Environmental Impact Assessment Report
New Nuclear Power Plant in Lithuania
27 March 2009

A P P E N D I X E S

1.1 Proposals from Austria and responses to these proposals

1.1.1 Proposals to EIA Report

Figure 1: Core damage frequency as reported in the EIA Report compared to other sources.

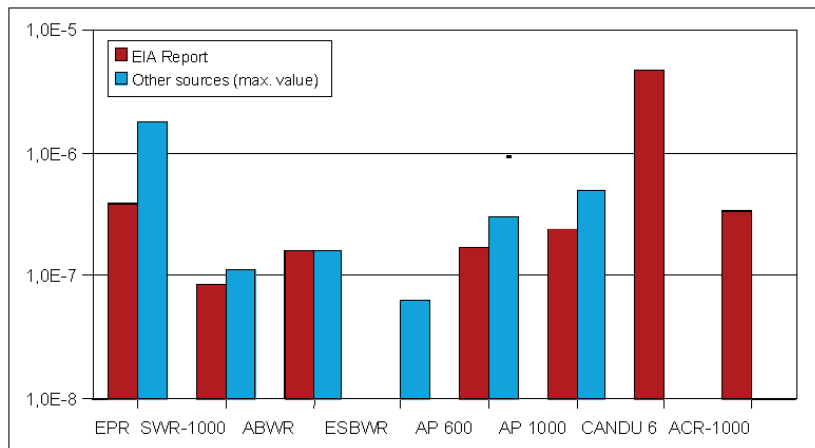
An evaluation and comparison of the numbers as provided in the EIA Report leads to the observations that CDF varies widely among reactor types – by a factor of almost 200. However, the relevance of the different CDF values for the assessment of different reactor types is not discussed in the EIA Report.

The synopsis of PSA results with their high variations and uncertainties (and possibly, inconsistencies) shows that it is not appropriate to rely too strongly on probabilistic criteria. The main criteria for the assessment of the reactor types should be deterministic.

A detailed presentation of the PSA results of the candidate reactors would be of interest (including the contributions of different events and plant states), as well as a discussion of their limitations and the bandwidths of their uncertainty. With this background, the differences in the results as indicated above should be discussed and assessed.

Figure 2: Example of deposition of Cs-137 over Europe resulting from a hypothetical severe accident in the new Ignalina NPP, assuming a release of 35.5 PBq in the hour after 1995-06-25 14:567. Output grid size is 1°. The outer border of the blue colour is at 0.1 kBq/m².

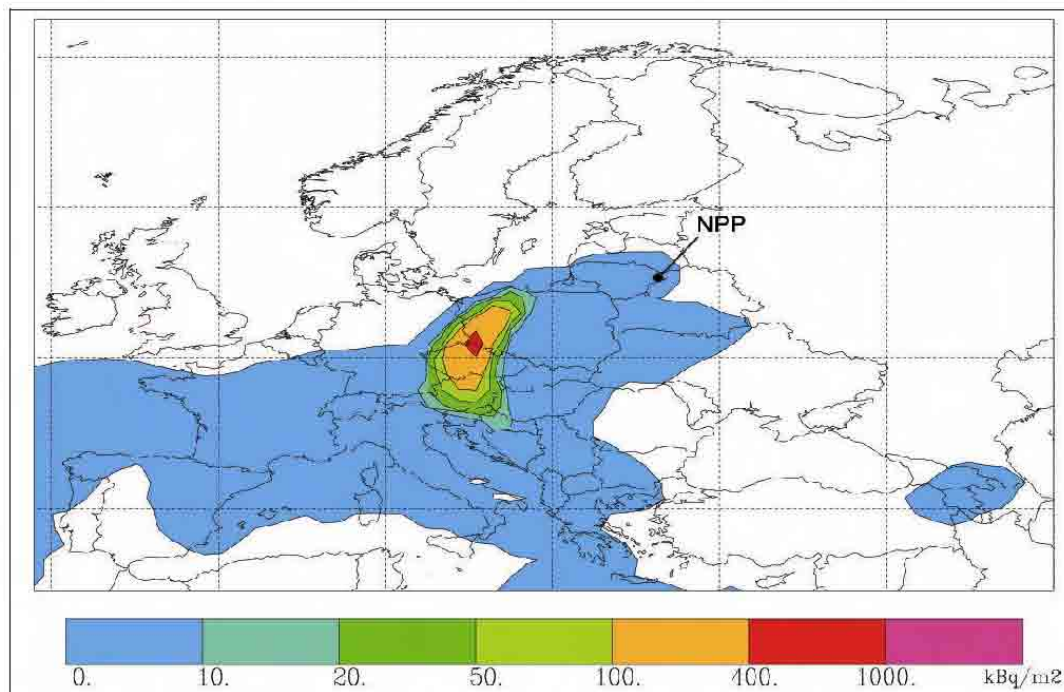
The method used for the evaluation of potential impacts to Austria due to a severe accident at the proposed new Lithuanian NPP is based on dispersion calculations made with the Lagrangian particle dispersion model FLEXPART in the RISKMAP project. In this project, 88 cases during the year 1995 were studied. Then the total (wet and dry) deposition of Cs-137 was evaluated over Europe. In Figure 2, we show the result for the worst case found among the 88 releases from the Ignalina NPP site, applying a source term of 5% from reactor inventory.

The figure shows a detached region affected by the contamination extending through Poland, the Czech Republic, and Austria to the region of former Yugoslavia. In Austria, a deposition of 100 kBq/m² is exceeded in a large part of Upper Austria. At this contamination level, radiation protection measures for the population in Austria would be required. Sheltering or even stable iodine prophylaxis could be ordered. During spring and summer food bans and restriction in stock farming could also be necessary if such a situation were to become reality.

Abbildung 1: Kernschmelzhäufigkeit (CDF) entsprechend dem UVP-Bericht verglichen mit anderen Quellen.

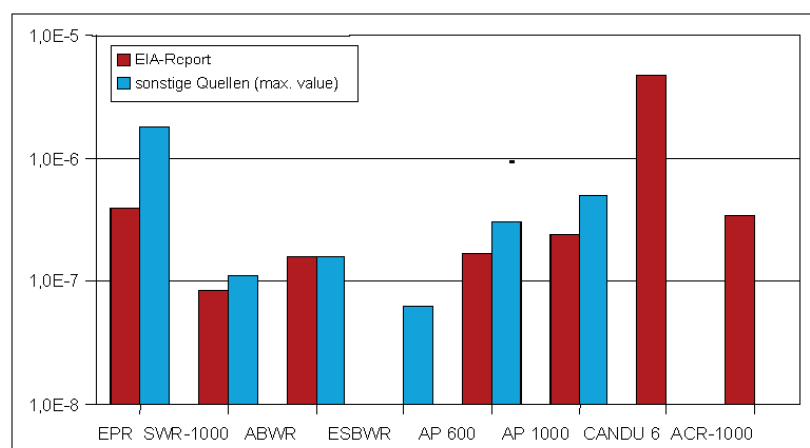
Die Bewertung und der Vergleich der Angaben im UVP-Bericht führt zur Feststellung dass die Kernschmelzhäufigkeit (CDF) große Unterschiede zwischen den Reaktortypen aufweist – bis zu einem Faktor 200. Die Bedeutung der unterschiedlichen CDF-Werte für die Bewertung der Reaktortypen wird im UVP-Bericht nicht erläutert.

Die Übersicht über die Ergebnisse probabilistischer Sicherheitsanalysen zeigt große Abweichungen und Unsicherheiten und belegt damit, dass es nicht angebracht ist zu sehr den probabilistischen Kriterien zu vertrauen. Die Hauptkriterien für die Bewertung der Reaktortypen sollten deterministisch sein.

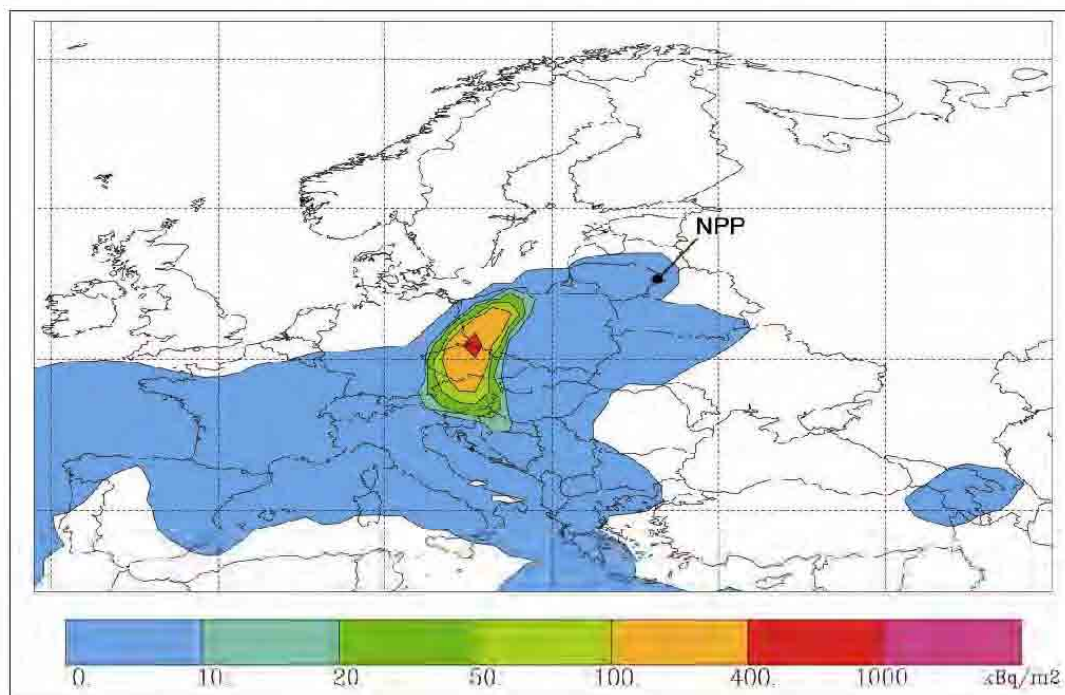
Die Methode der österreichischen Untersuchung der potentiellen Auswirkungen eines schweren Unfalls im vorgeschlagenen neuen litauischen KKW beruht auf Ausbreitungsrechnungen, die mit dem Modell FLEXPART (Lagrange-Partikel-Dispersionsmodell) im Projekt RISKMAP eingesetzt wurde. In diesem Projekt wurden 88 Fälle aus dem Jahr 1995 untersucht. Die Verteilung der Gesamtd deposition von Cäsium 137 (trocken und nass) über Europa wurde ermittelt. Abbildung 2 zeigt das Ergebnis für die maximale Kontamination aus diesen 88 Simulationen einer Emission am Standort des Litauischen KKW, berechnet mit einem Quellterm von 5 % des Cs-137 Inventars.

Die Abbildung zeigt die von der Kontamination betroffene von KKW abgelegene Region, die sich über Polen, die Tschechische Republik und Österreich bis in das Gebiet des früheren Jugoslawien erstreckt. In Österreich liegt die Deposition über dem Wert von 100 kBq/m² in einem großen Teil von Oberösterreich. Bei dieser Kontamination sind Maßnahmen zum Schutz der Bevölkerung vor Strahlenbelas-

Figure 3: Core damage frequency as reported in the EIA Report compared to other sources.

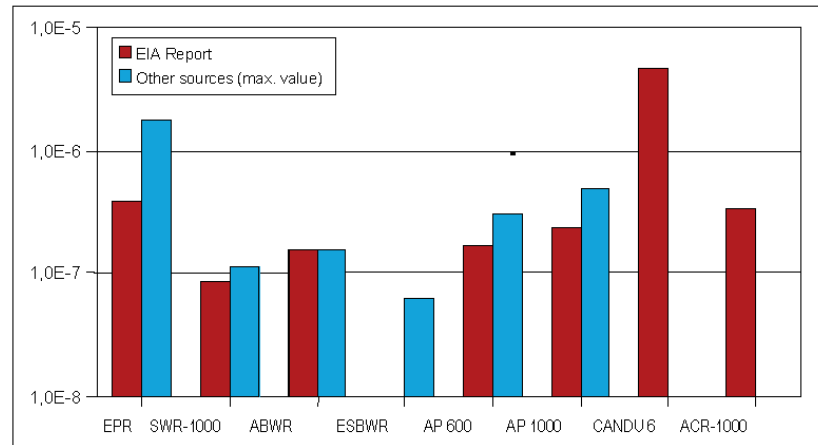
The relevance of the different CDF values for the assessment of different reactor types and their candidate status is not discussed in the EIA Report; not even in cases where the CDF as reported in the EIA Report is close to the probabilistic requirement.

Furthermore, there is no discussion of the variations regarding the CDF/LRF ratio, and reason for the variations. Differences in the CDF/LRF ratio could indicate fundamental differences in reactor design, particularly regarding the control of core damage accidents. On the other hand, they could also be indicative of methodological inconsistencies and/or of high bandwidths of uncertainty in the level 2 PSAs of some reactor types.

Figure 4: Large release frequency as reported in the EIA Report compared to other sources.

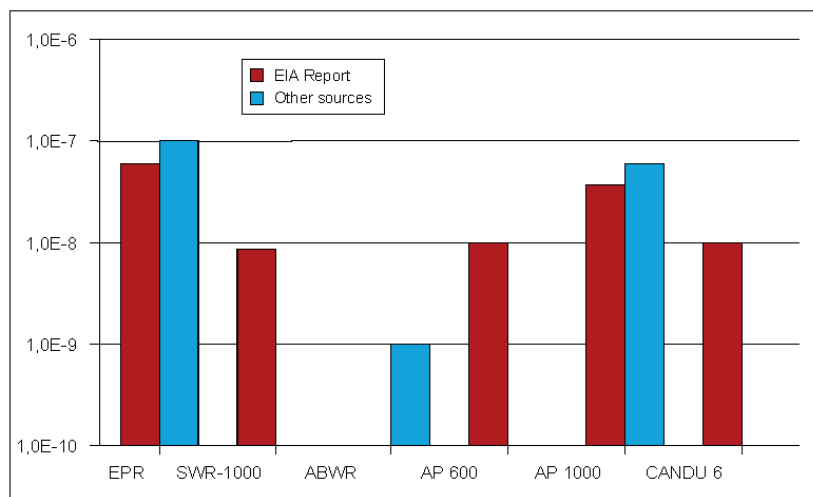
Altogether, the synopsis of PSA results with their high variations and uncertainties (and possibly, inconsistencies) shows that it is not appropriate to rely too strongly on probabilistic criteria. The main criteria for the assessment of the reactor types should be deterministic, with the results of probabilistic studies as a supplement only.

Figure 5: Example of deposition of Cs-137 over Europe resulting from a hypothetical severe accident in the new Ignalina NPP, assuming a release of 35.5 PBq in the hour after 1995-06-25 14:567. Output grid size is 1°. The outer border of the blue colour is at 0.1 kBq/m².

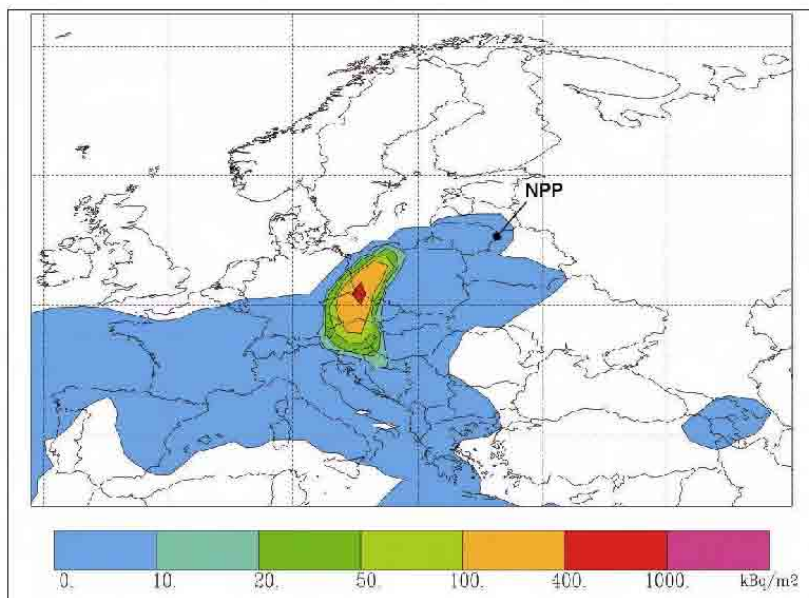
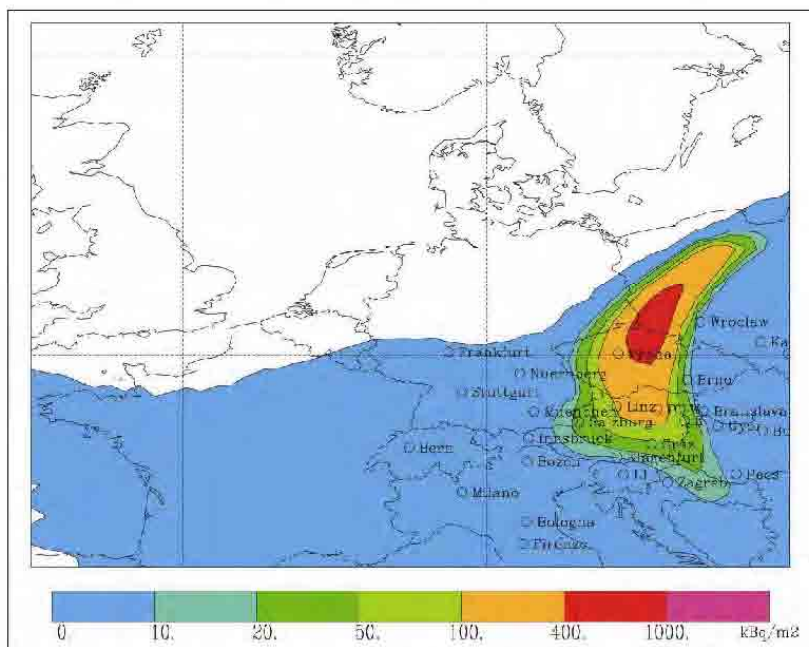
In Figures 5 and 6, we show the result for the worst case found among the 88 releases from the Ignalina site, applying a source term of 5% from reactor inventory – see chapter 8.1.5. We consider this a possible release in the case of a severe accident in a "Generation III" reactor. The first illustration (fig 5) gives an overview of the contamination in Europe caused by the release. Fig. 5 shows all of Europe with a coarser output resolution, Fig. 6 shows only central Europe but with an improved resolution of 0.5° in E-W direction and 0.33° in N-S direction. Due to the

We see a detached region of contamination extending through Poland, Czech Republic, and Austria into the region of former Yugoslavia. In Austria, a deposition of 100 kBq/m^2 is exceeded in a large part of Upper Austria. At this contamination level radiation protection measures for the population in Austria would be required.
